# PRODUCT CHANGE NOTIFICATION

## Bourns® Model SM13117EL PoE Flyback Transformer

### Marking Process Change

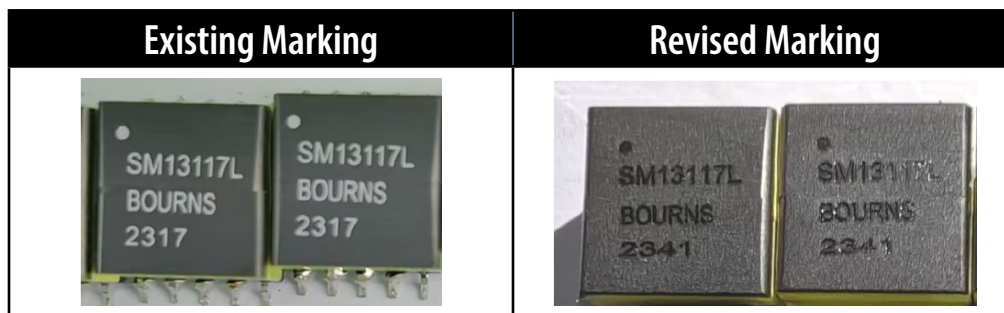
Riverside, California – June 17, 2024 – In the spirit of continuous improvement, effective August 31, 2024, Bourns will change the marking process from ink printing to laser etching for the [Model SM13117EL PoE Flyback Transformer](#). The affected part number is provided below.

The form will change slightly due to the change to the marking method. The fit and function of the affected transformer will remain the same. The new marking process will increase marking durability. The quality and reliability of the transformer should be improved as a result of the change. Traceability will be maintained through lot code and date code.
